Re: Special Environmental Analysis, DOE/SEA-04
Potomac River Generating Station
Reply to Comments

You have asked ENSR to review the letter dated January 5, 2007, sent by Richard J. Baier, to Donald S. Welch and David K. Paylor (the "Letter"). The Letter purports to be a review and critique of the Wind Tunnel Modeling Evaluation for the Mirant Potomac River Generating Station, Final Report (the "Study"), dated August 29, 2006, and prepared by CPP, Inc.

Figure 1: Stack Exit Configuration

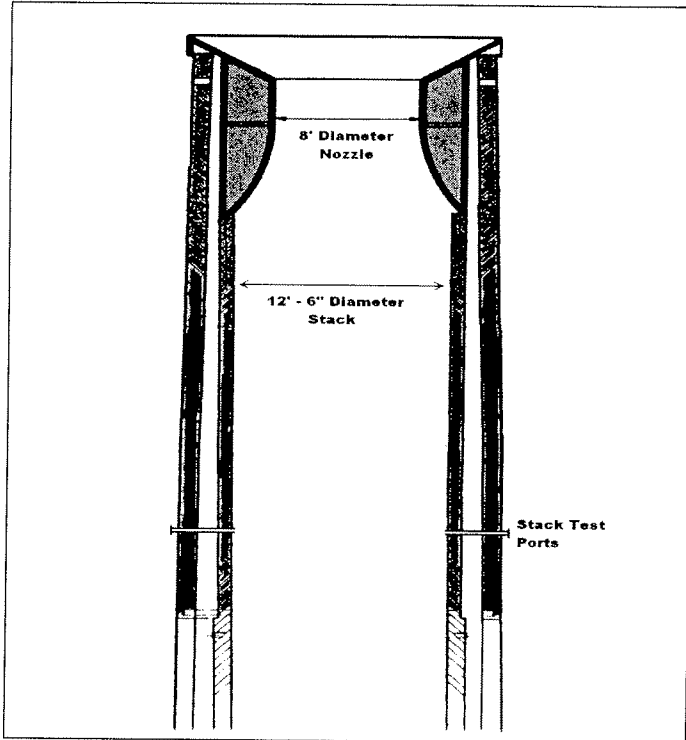
3. *"The Wind Tunnel Study used stack-exit velocity that significantly overstates plume momentum."*

Response: In Table 3 of the Letter, the City presents stack gas exit velocities from recent stack testing: 17.5 m/sec for stack 1 and 14.6 m/sec for stack 5. These values are correct for the location where the stack tests were taken. These values are not the stack gas exit velocities, however. The wind tunnel used velocities of 25.5 m/sec and 21.5 m/sec for stacks 1 and 5. These values are the gas velocities at the stack exit where there is a nozzle on each stack that restricts the stack inner diameter. The nozzles are part of the original design due to FAA stack height restrictions. The nozzles were placed at the stack exit to increase velocity. The wind tunnel used the correct stack gas exit velocities. See Figure 1.

Figure 3: Q-Q Plots of 24-hour Predicted vs. Observed Concentration, When Observed Concentration > 15 $\mu\text{g}/\text{m}^3$

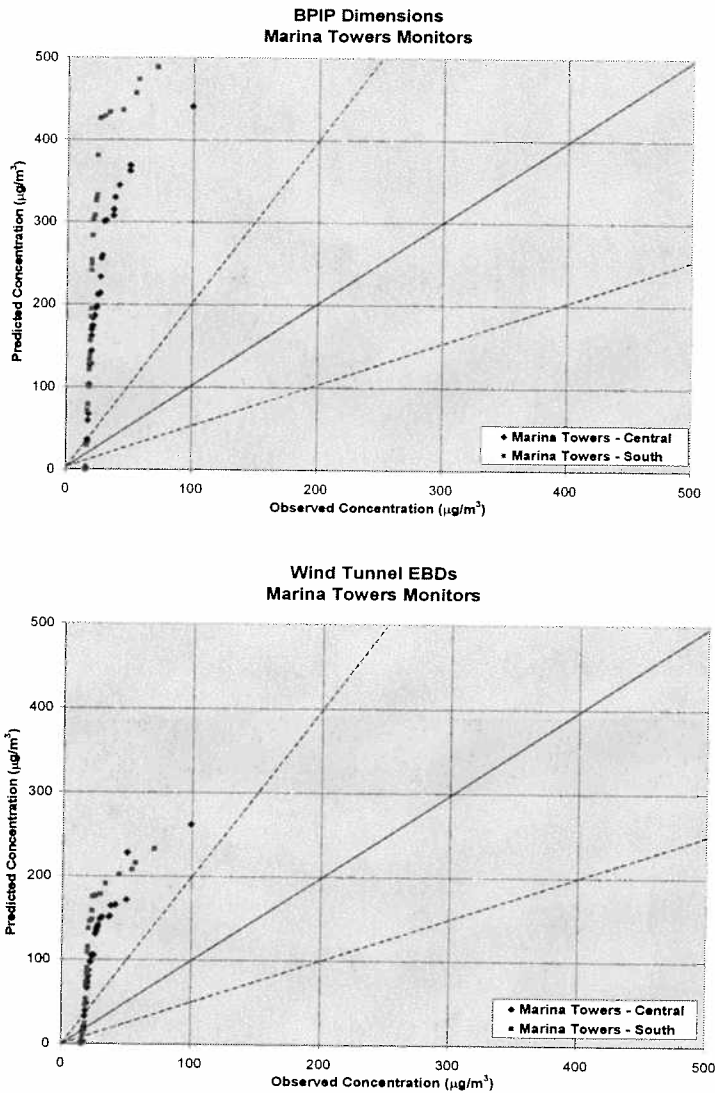
"Approval of the EBDs set out in the Wind Tunnel Study would lead to higher power output rates by the PRGS and higher impacts."

Response: The EBDs were run in AERMOD and predicted concentrations were lower than AERMOD run in default mode. However, as shown in Figure 3, AERMOD/default (upper figure) and AERMOD/EBD (lower figure) predict significantly higher values than actual observed concentrations in ambient air. Therefore, use of the EBDs developed in the wind tunnel is protective of public health.

Figure 4: Wind Tunnel Concentrations

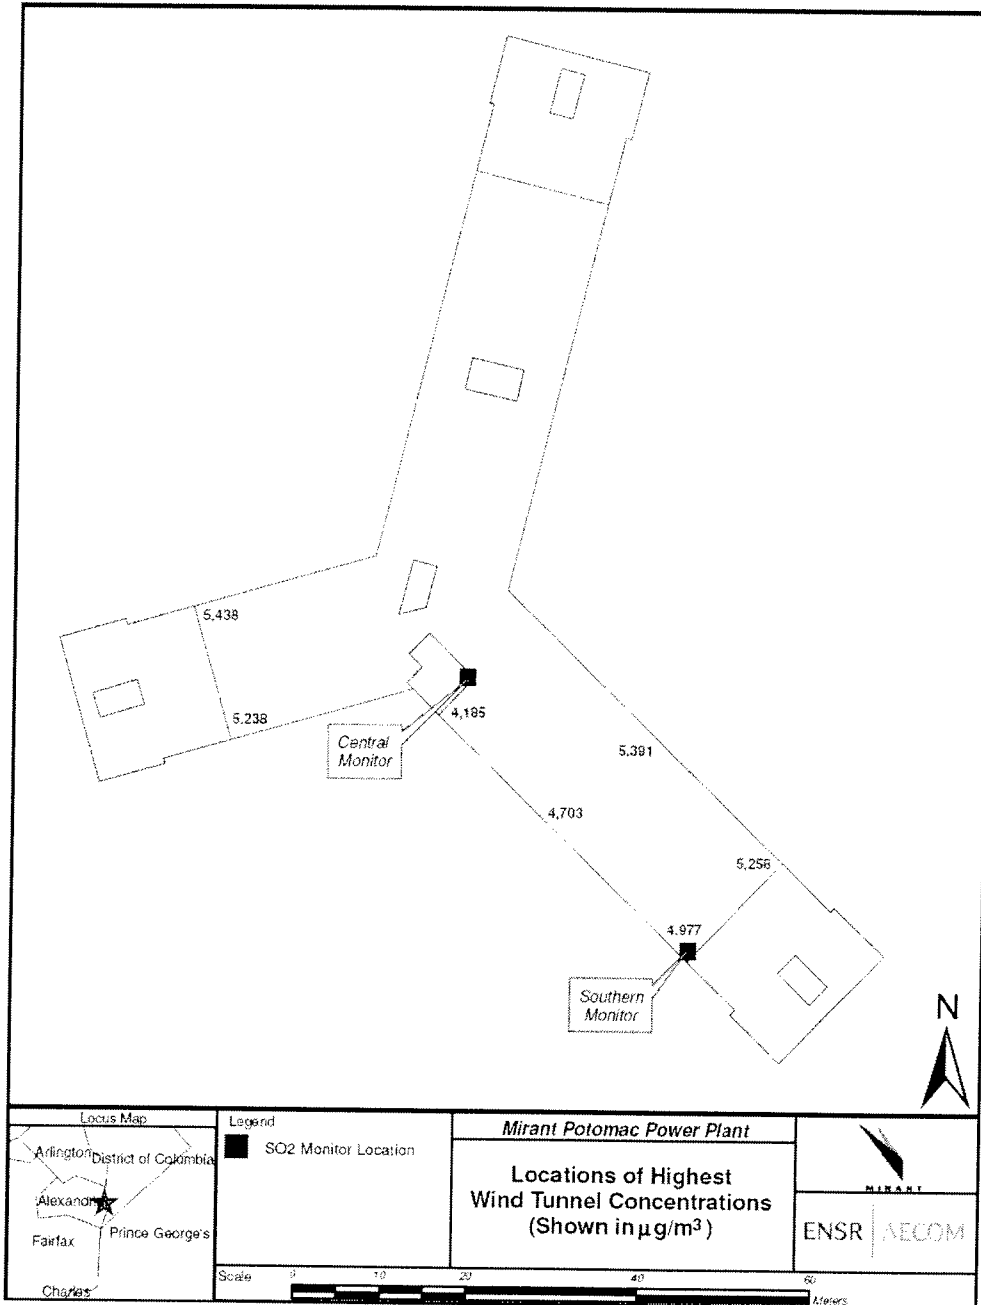
"Actual full-scale simulation results from the Wind Tunnel Study show that monitoring of the facility's operations through placement of only two monitors on Marina Towers – on the rooftop at the southeastern-most point and center – is grossly inadequate."

Response: Figure 4 shows the top of Marina Towers roof. The location of the highest concentrations measured during the Study are shown and the location of the two ambient SO₂ monitors are also shown. The highest wind tunnel concentration of 5,438 µg/m³ was measured on the west wing during a 160° wind direction. The next highest value of 5,391 µg/m³ was measured on the SE wing between the locations of the two Mirant SO₂ monitors during a wind direction of 170°. A wind direction of 165° would have transported power plant gases directly toward the central monitor resulting in a measured concentration higher than the 4,185 µg/m³ value shown in the figure. However, this direction was not included in the Study. The highest values for the 170° (5,391 µg/m³) and 160° (5,438 µg/m³) wind directions are within 1% of each other. Therefore, the two SO₂ monitors are located appropriately to measure highest plant-related impacts.
